ORE - TRAFFIC: Jan 2026 Proposed TEM Updates Summary

Each proposed revision (row below) is bookmarked in the document

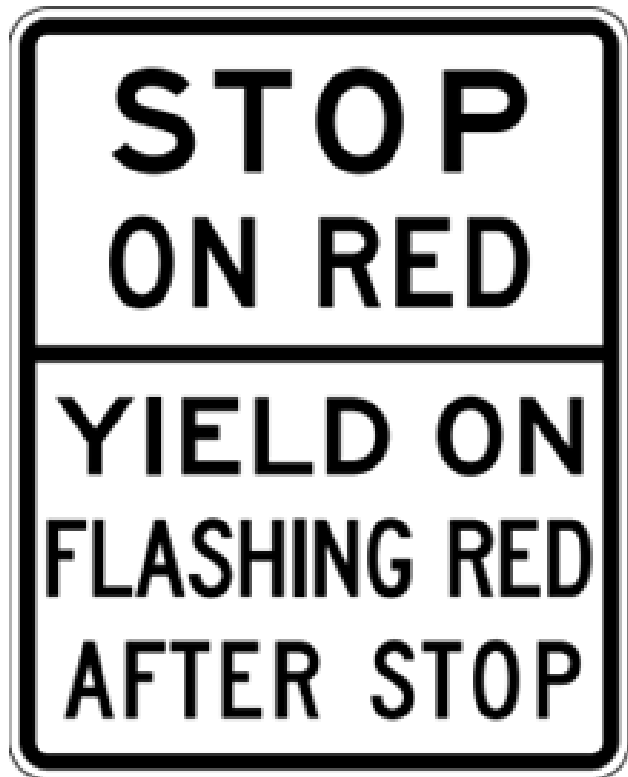
~~The KEEP RIGHT EXCEPT TO PASS sign may be used on Interstate highways with two lanes in the same direction, and on non-Interstate freeways, based on engineering judgment.~~

TEM 298-42 Draft
Updated Figure(s)

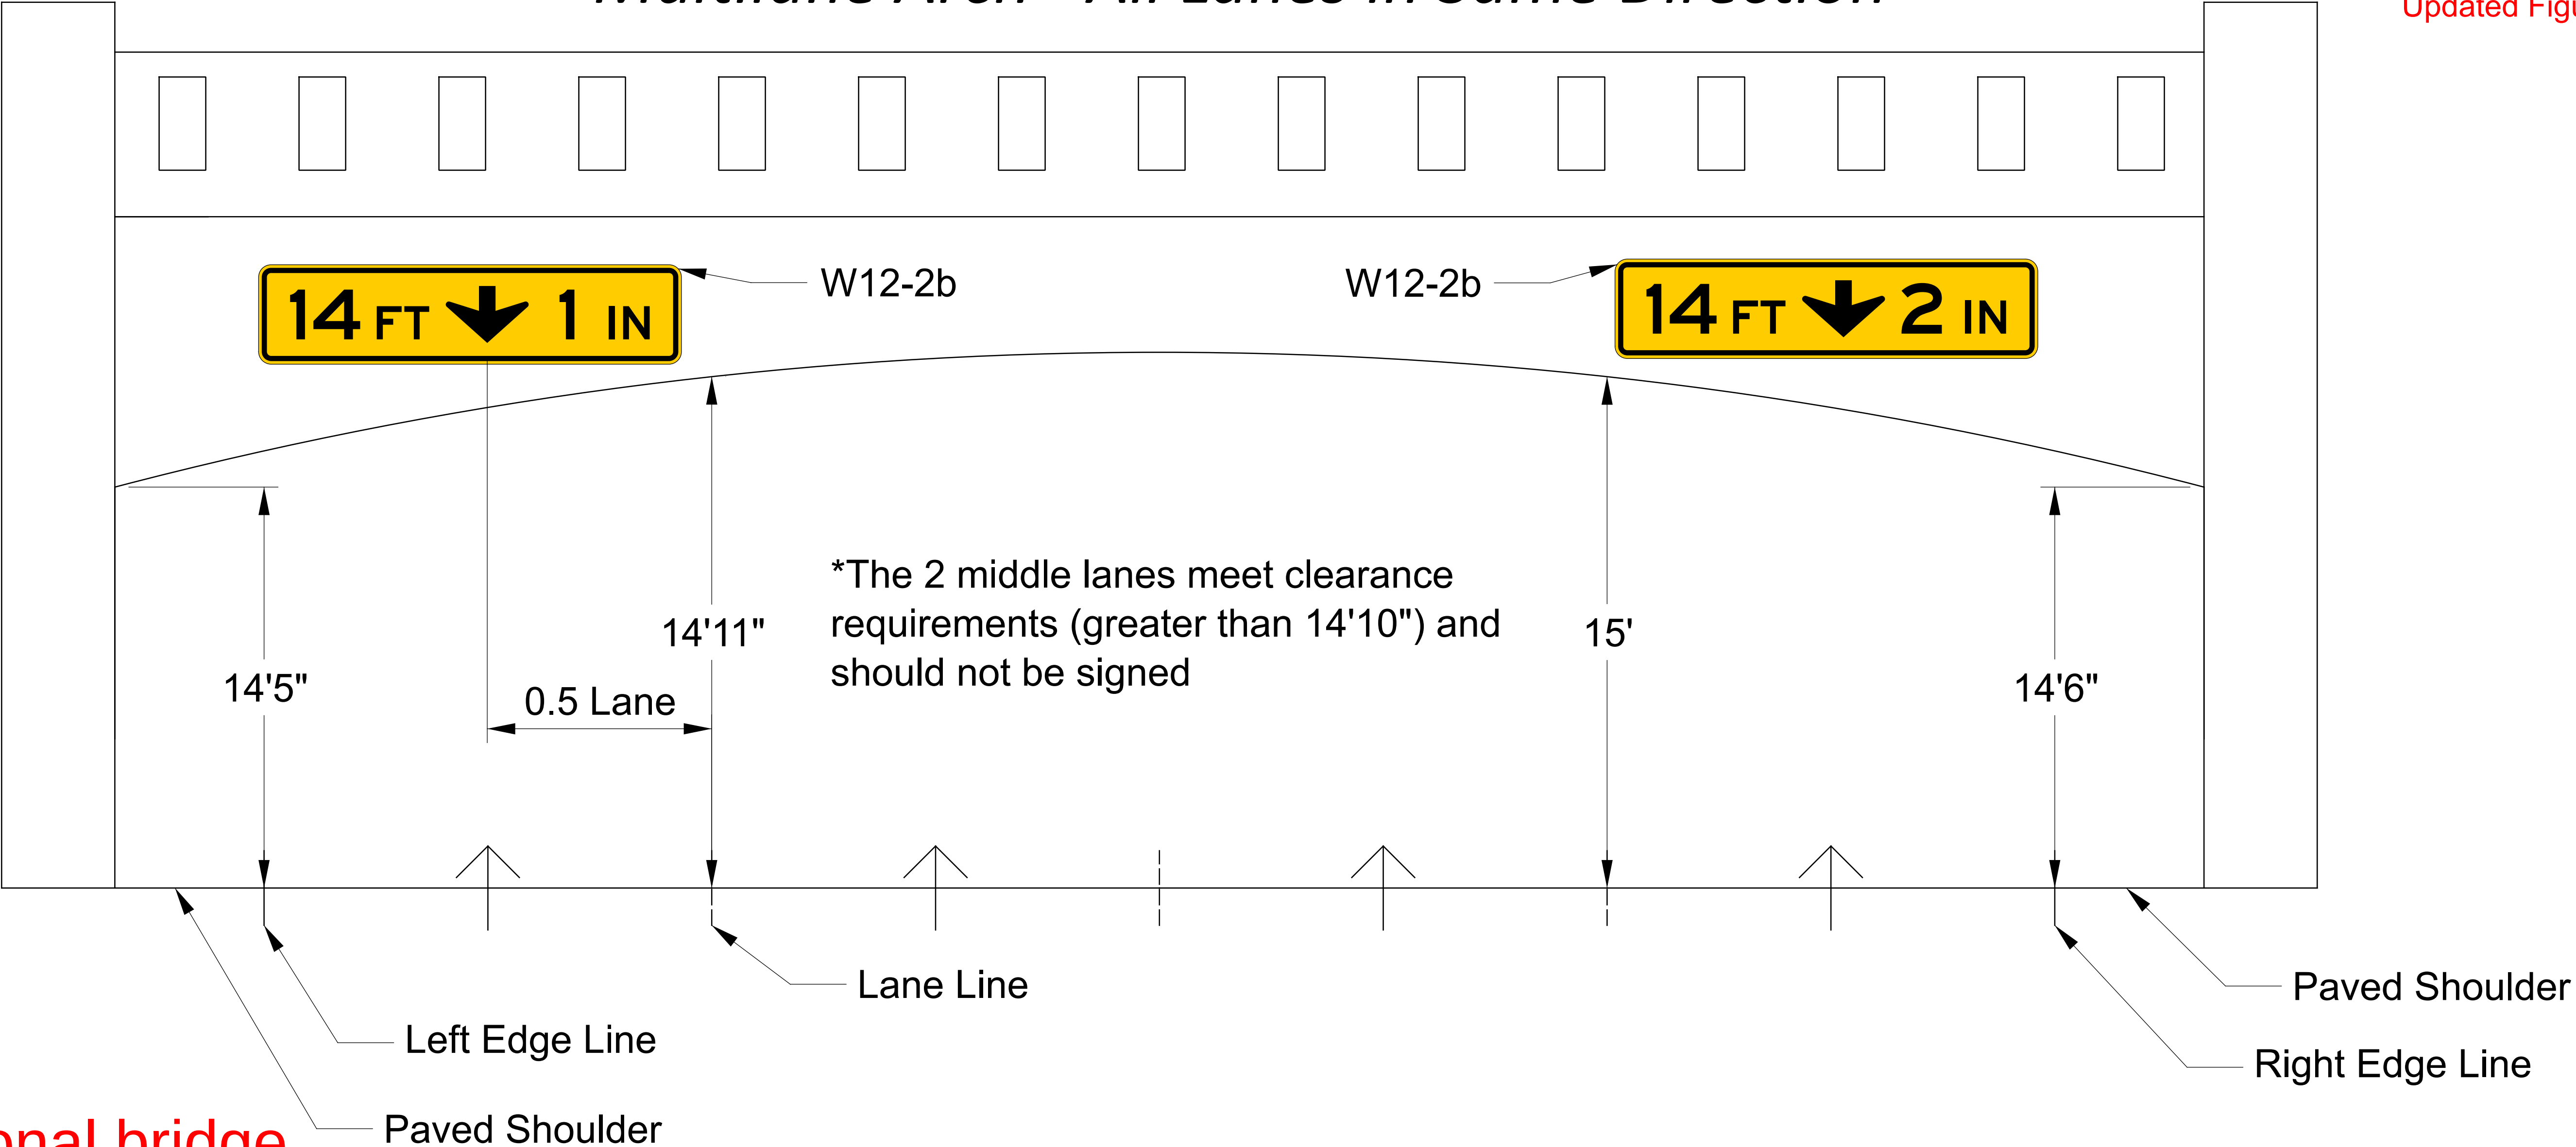
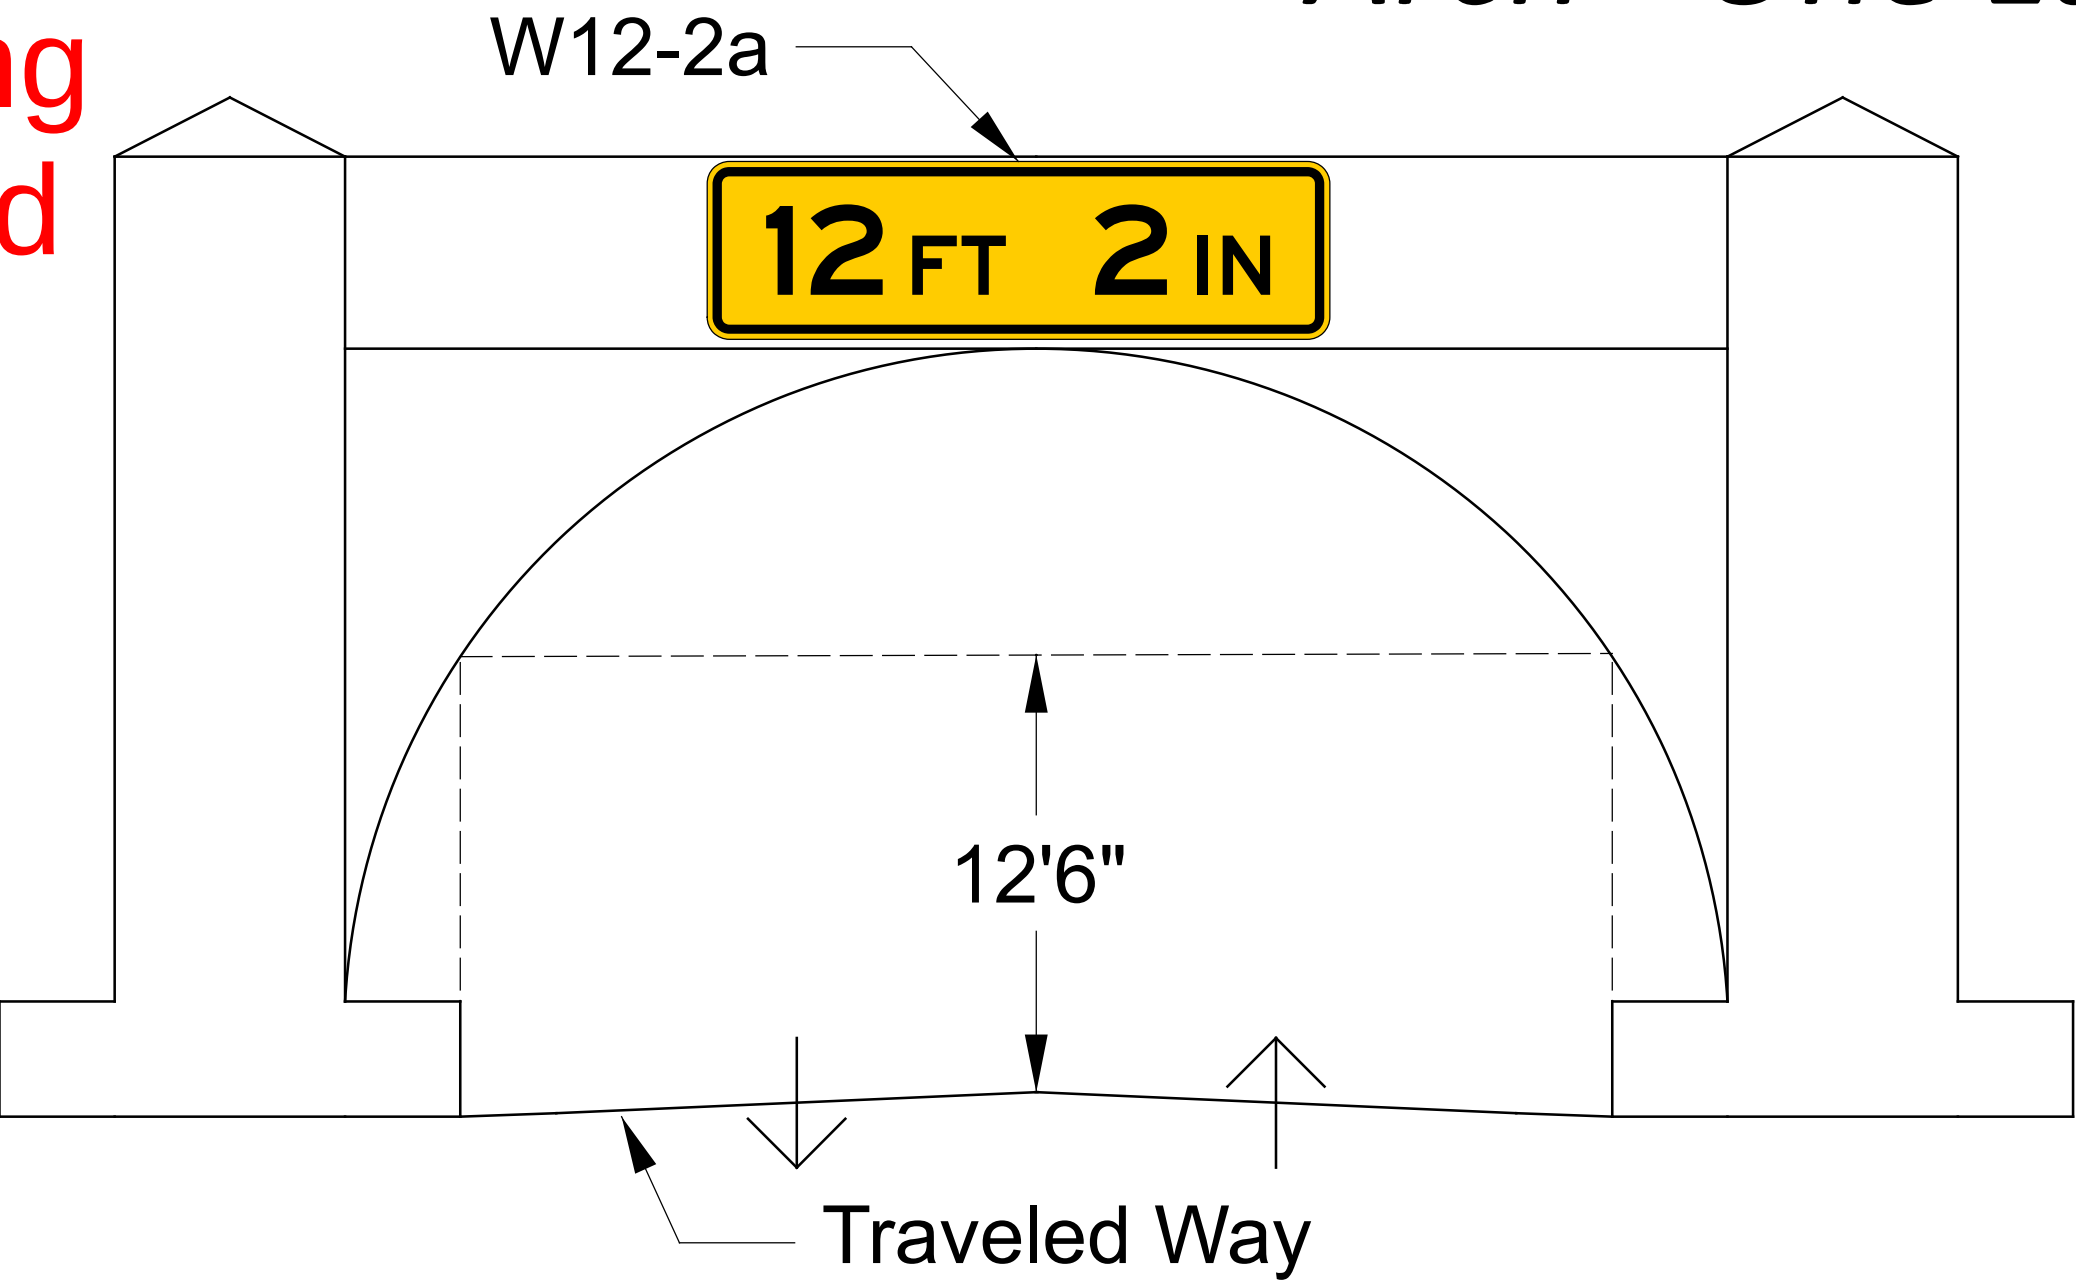
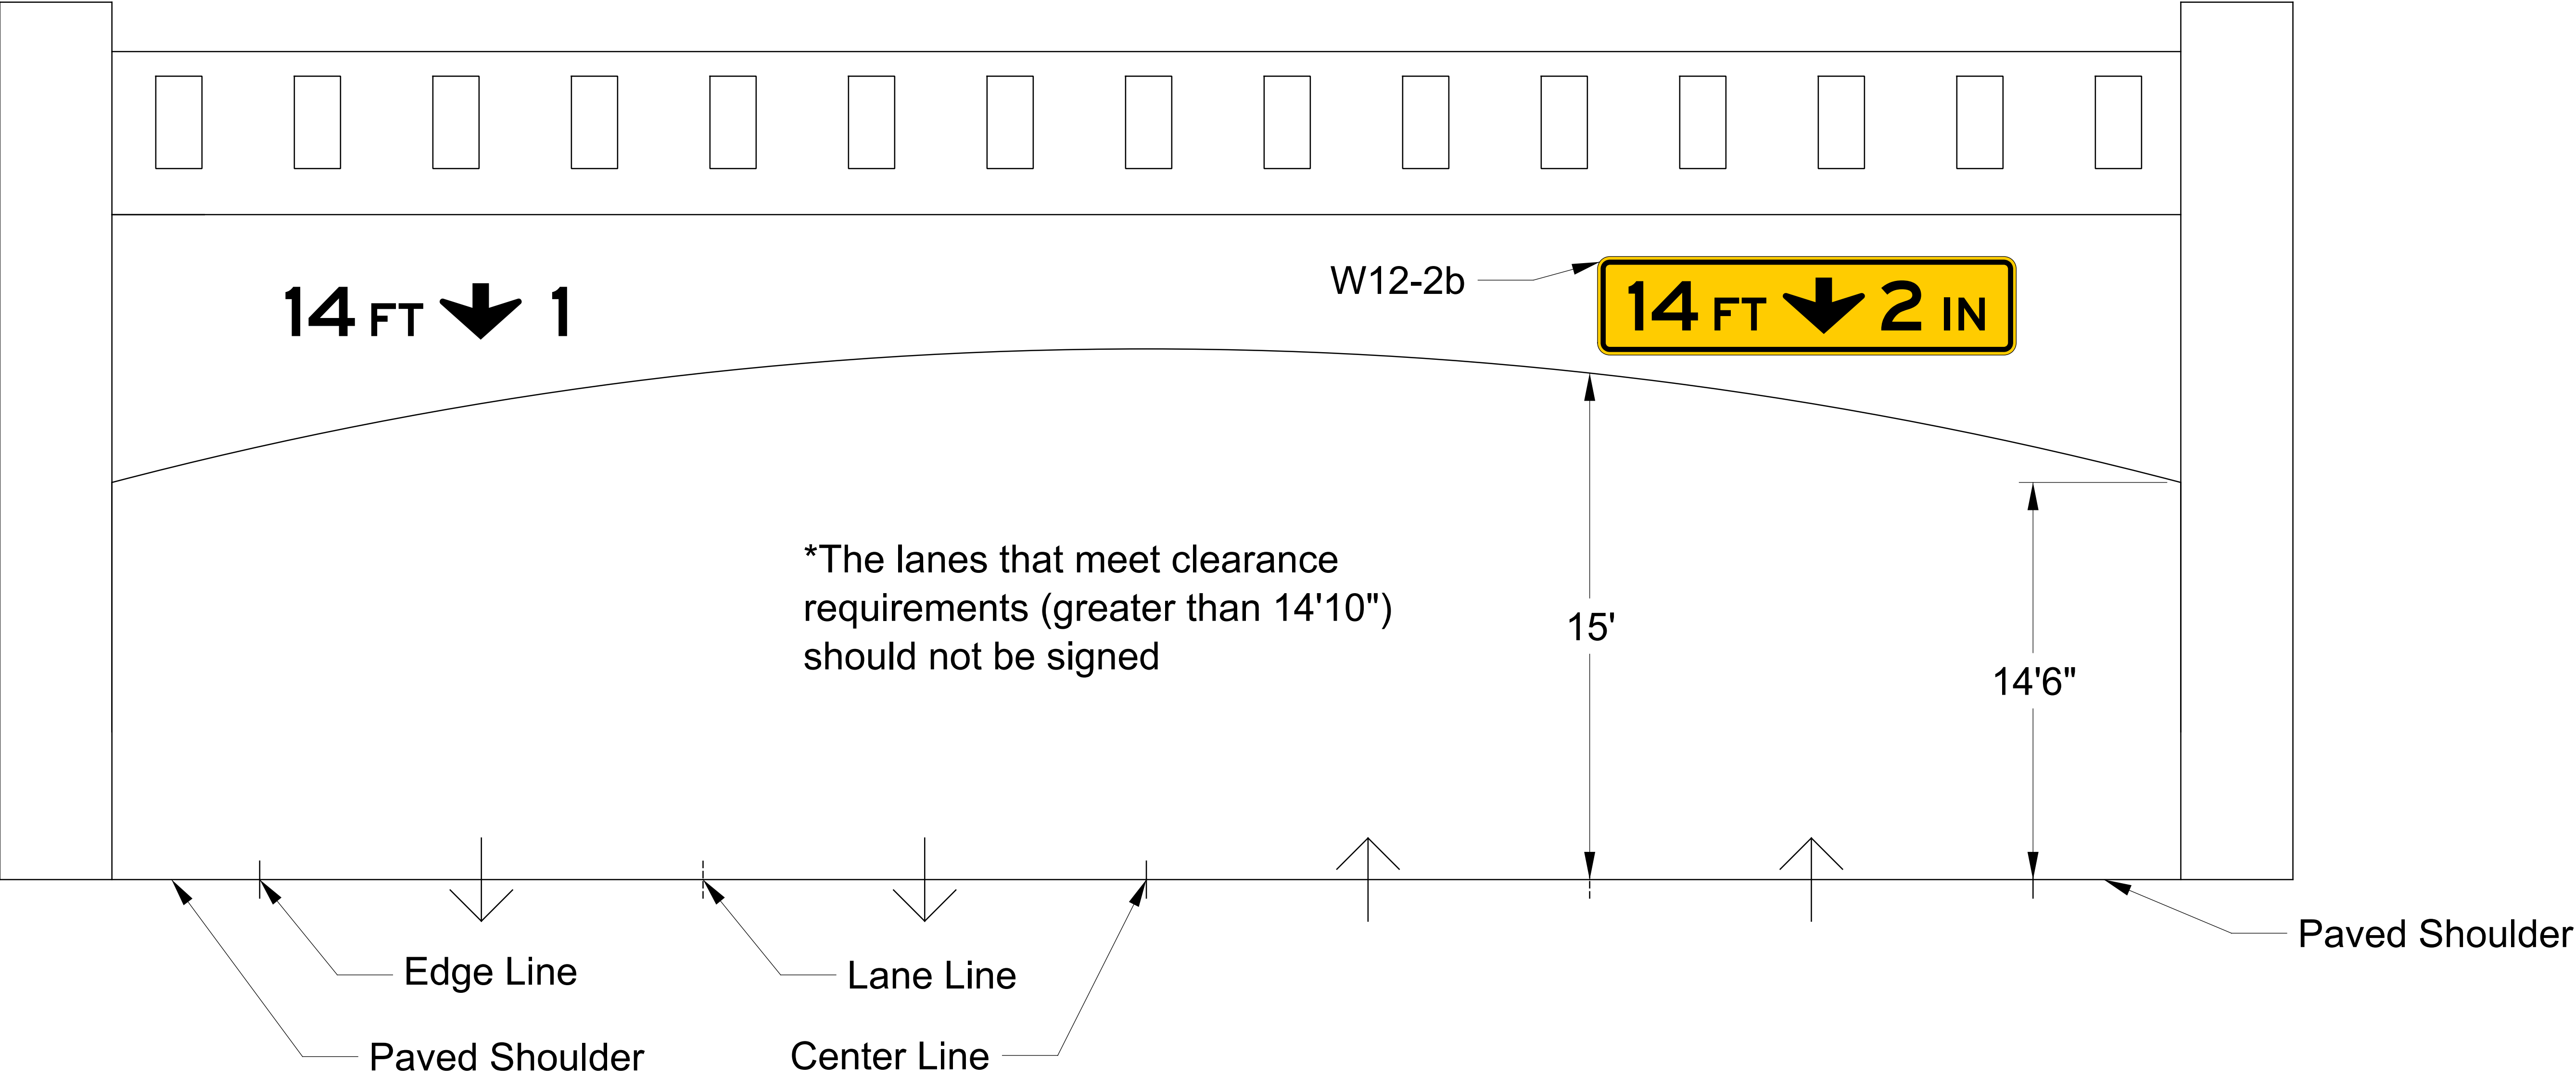
Added Additional bridge
posting layouts, and
Examples of signs being
posted on freeways and
conventional routes

NOTE:
All Low Clearance Signs displayed on bridge
use a 4" buffer from the actual low vertical
clearance (Actual Height - 4")
